CITY OF ALBUQUERQUE

Re: 1st Nations Community Health Source
5608 Zuni RD SE
Traffic Circulation Layout
Architect's Stamp 07-21-17 (L18-D047)

SHEET TITLE
**ARCHITECTURAL
SITE PLAN FOR
TRAFFIC CIRCULATION
LAYOUT**

AS-TCL

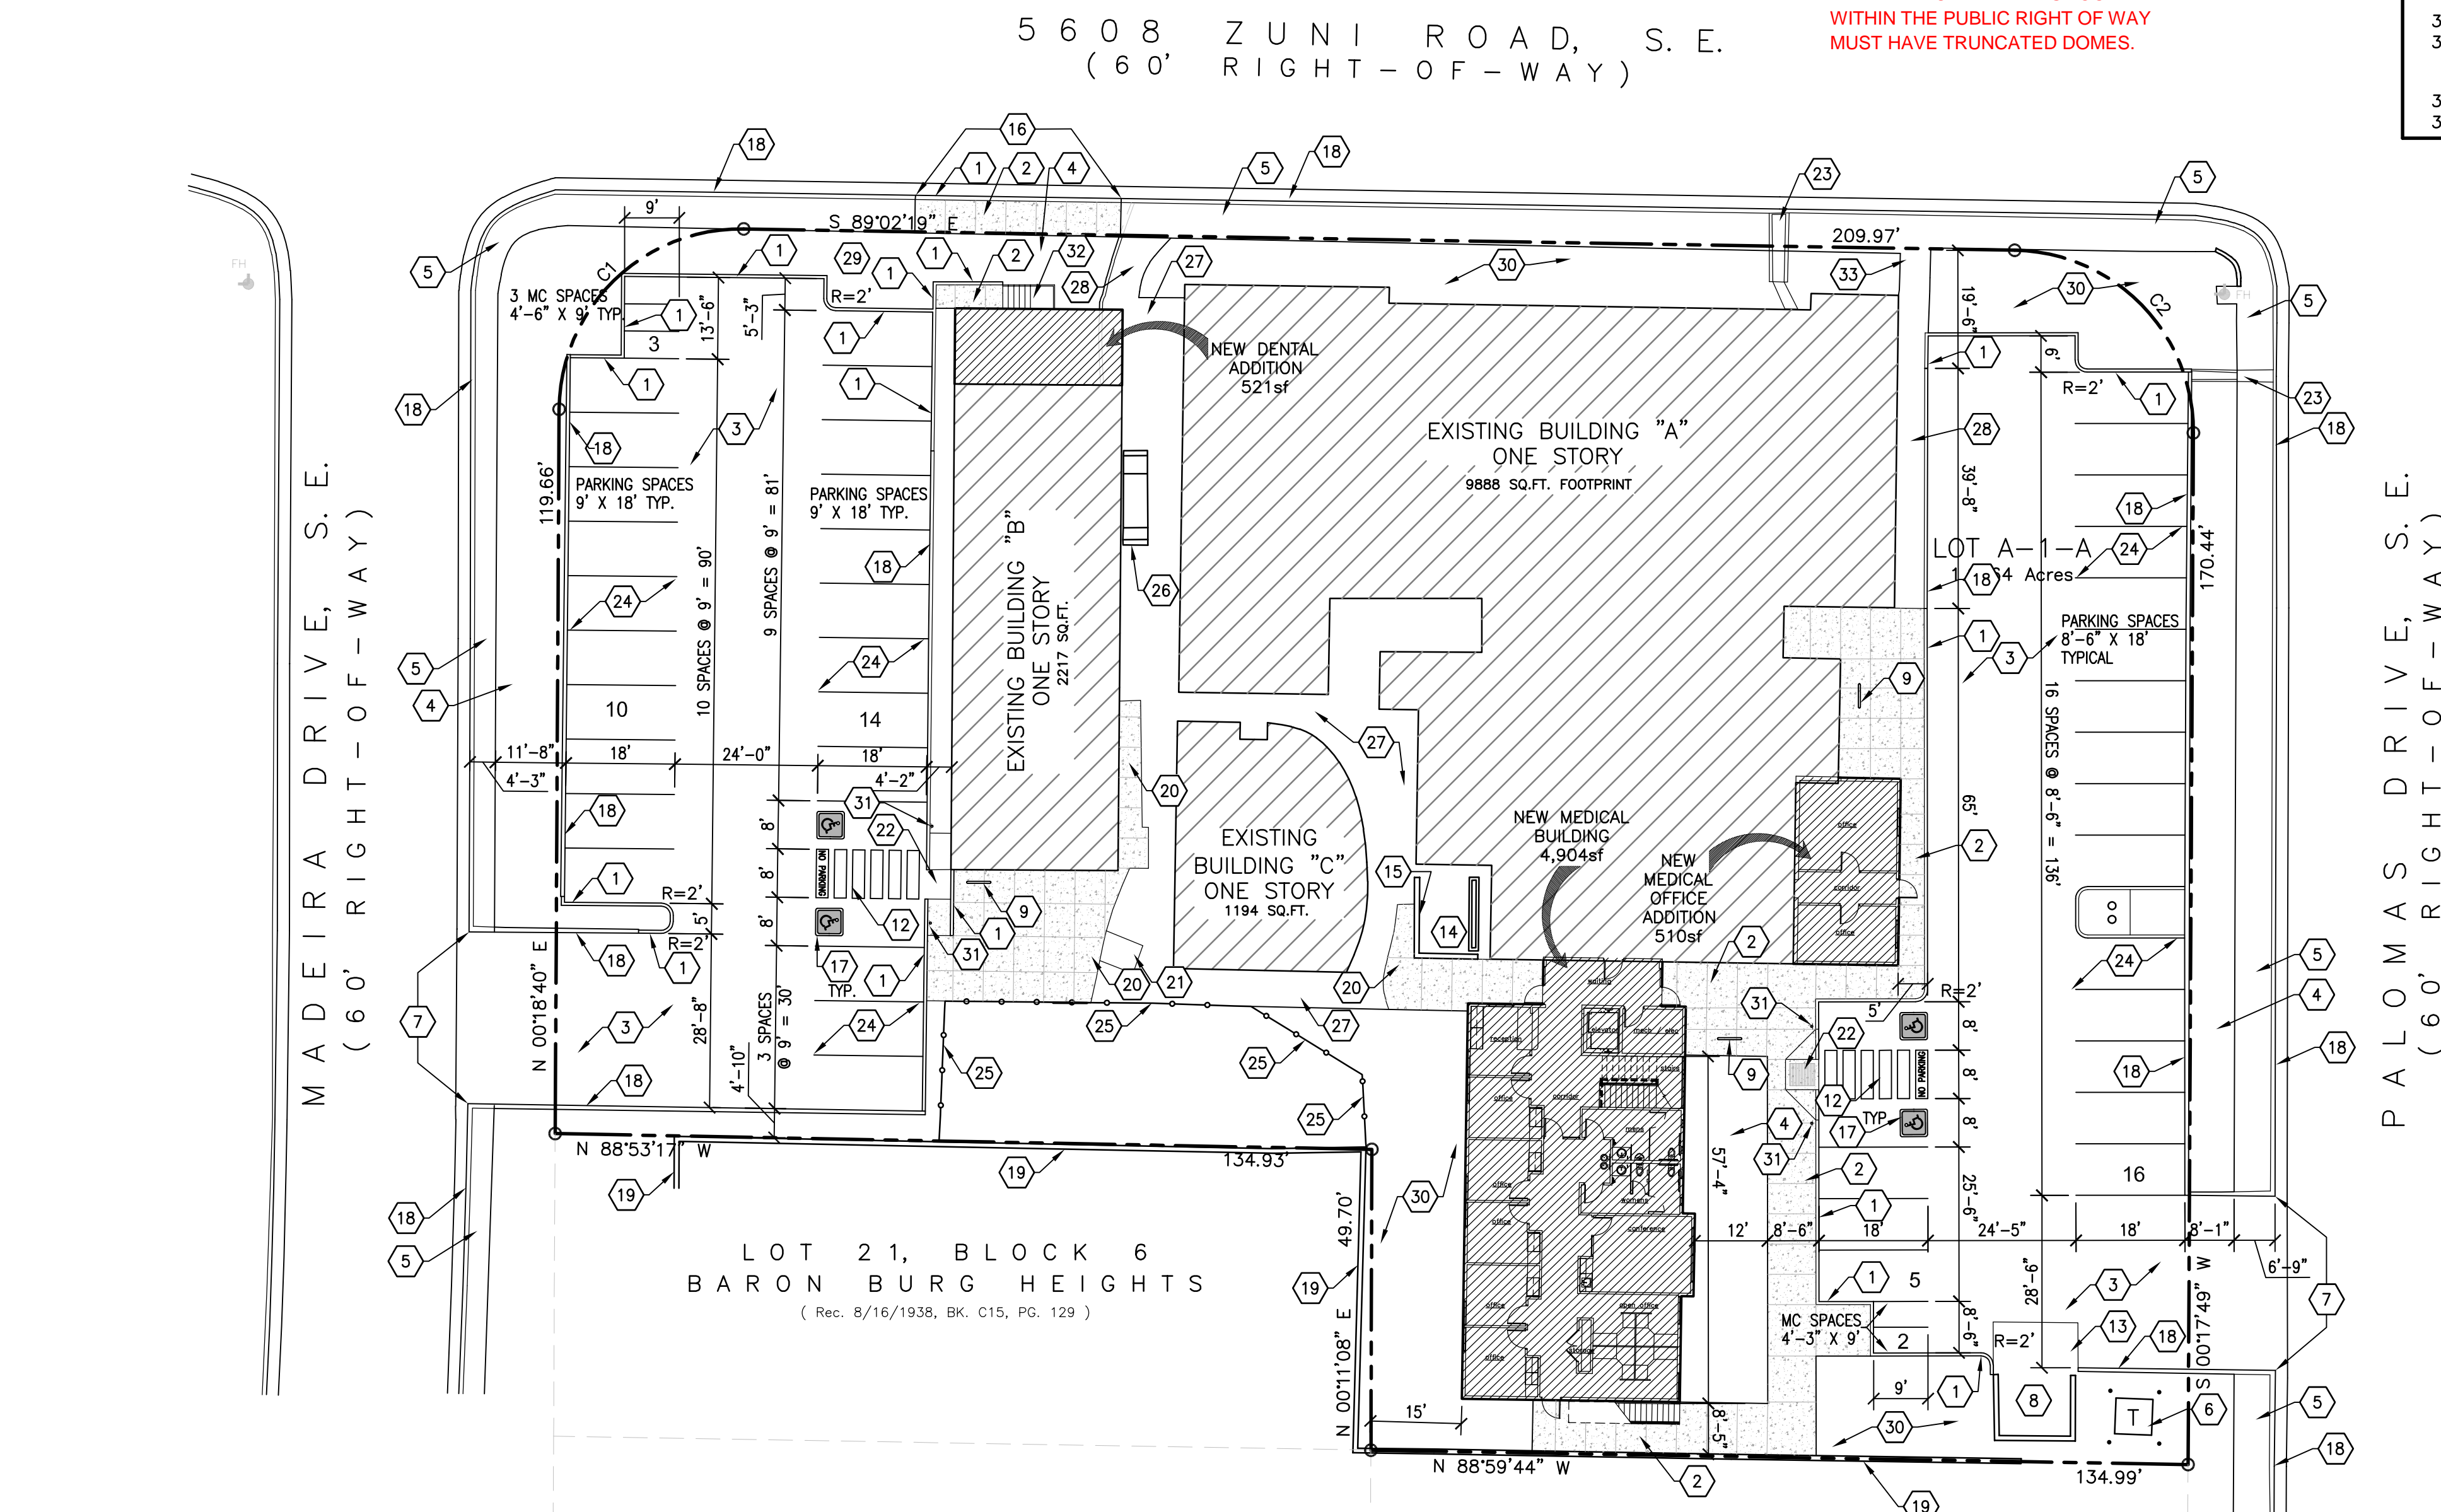
TRAFFIC CIRCULATION
LAYOUT APPROVED

ALL WHEELCHAIR RAMPS LOCATED
WITHIN THE PUBLIC RIGHT OF WAY
MUST HAVE TRUNCATED DOMES.
